STATE OF WASHINGTON
DEPARTMENT OF ECOLOGY

May 7, 2007

**Re: Further Action Determination WAC 173-340-515(5) for the following
Hazardous Waste Site:**

Spic'n Span Cleaners, Inc.
652 South Dearborn Street,
Seattle, Washington 98134
Facility/Site No. 54766547
VCP No.: NW 0945

Groundwater Elevation Contour Map
Spic 'n Span Cleaners Site

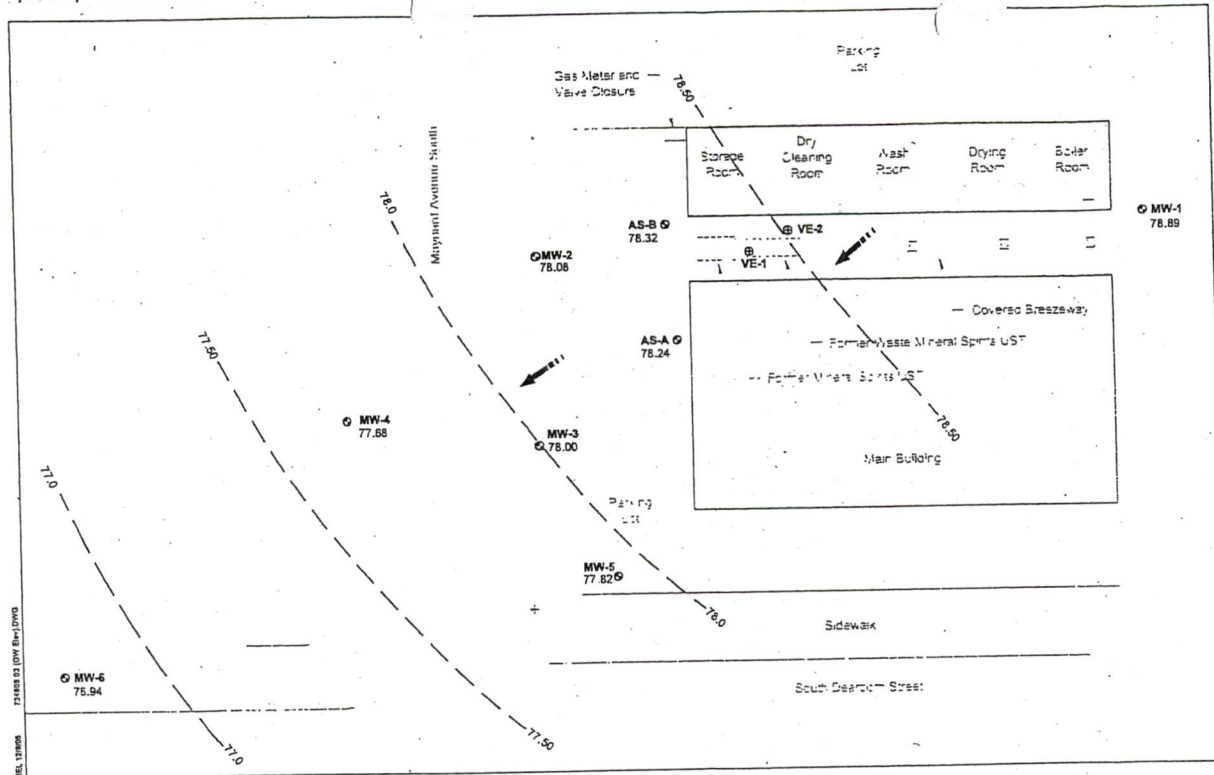
- f) The groundwater flow direction is not established: the depicted flow direction in Figure 3 of the December 12, 2005, report is likely to the southwest because the axis of the well locations runs northwest to southwest. Also, the date of measurement is not shown, and a single measurement does not establish flow direction in the water table aquifer. Determining the flow direction requires at a minimum, groundwater flow maps with contours of equal hydraulic potential supported by groundwater elevation data for the seasonal high and low groundwater conditions. Finally, the construction details have a bearing on water level measurement, and the details to the monitoring wells are not complete. (Refer to next comment for completion.)

- g) The well completion logs for monitoring wells MW-1, MW-2, MW-3, and MW-4, shown on Figure 3 of the December 12, 2005, report, are contained in the June 15, 2000, report. However, the well completion logs for monitoring wells VE-2, VE-1 AS-B, AS-A, MW-5, and MW-6 are not found. Please compile in one location in the file, all well completion logs for monitoring wells to be used.
